Access Compliance Report

Public Rights-of-Way

Intersection ID: 2771	Main Street: MAYAPPLE_LN	Cross Street: RIDGEFIELD_DR	Location:	W
ADA ID: 53D8ECE728D9	Ramp Type: Perp	Initial Pass/Fail: Fail	Overall Compliance: No	Severity Score: 12.5

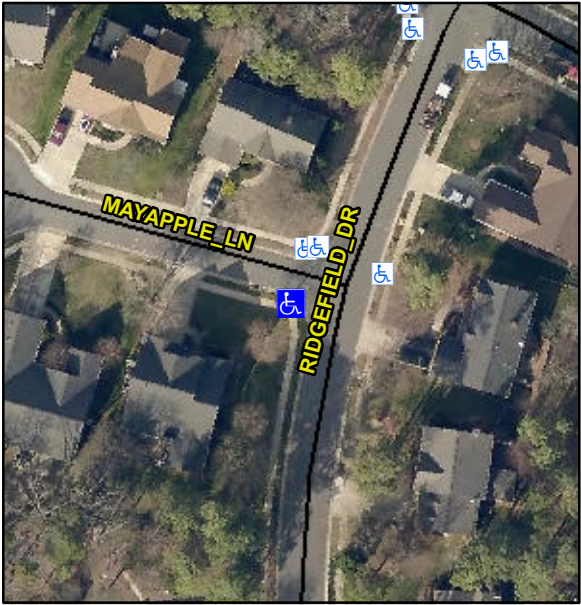
Codes/Mitigation Info/Possible Solution			Field Measurements/Component Compliance		
	Possible Solutions:		Compliance	Description	Data
	Remove & Replace Entire Ramp.		No	Ramp Length (in)	49.0
			Yes	Ramp Width (in)	48.0
			N/A	Flare Type LT	N/A
			N/A	Flare Slope LT (%)	N/A
			N/A	Flare Traversable LT?	N/A
			N/A	Landing Length (in)	N/A
			N/A	Landing Width (in)	N/A
			N/A	Landing Slope (%)	N/A
			N/A	Landing X Slope (%)	N/A
<p>Surveyor Notes:</p> <p>N/A</p> <p>PROW/ADA:</p> <p>Not Found, R304.2.2</p>			N/A	Flare Type RT	N/A
			N/A	Flare Slope RT (%)	N/A
			N/A	Flare Traversable RT?	N/A
			N/A	DWS Provided?	N/A
			N/A	DWS Contrast?	N/A
			N/A	DWS Length (in)	N/A
			N/A	DWS Full Width?	N/A
			N/A	DWS Offset (in)	N/A
			N/A	Shared Landing?	N/A
			N/A	Gutter Ponding?	N/A
			N/A	Gutter Lip Ht (in)	N/A
			No	Painted X Walk1?	N/A
				X Walk 1 Direction	To NE
			N/A	X Walk 1 Width (in)	N/A
				X Walk 1 Slope (%)	2.9
				X Walk 1 X Slope (%)	2.8

N/A	Ramp inside XWalk1?	N/A
			N/A	Road Slope (%)	N/A
			N/A	Road X Slope (%)	N/A
			N/A	Any Obstructions?	N/A
				Obstruction Type	
			N/A		
			N/A		
			N/A		
			N/A		
			N/A		
			Yes	Surface Condition? (G/P)	Good
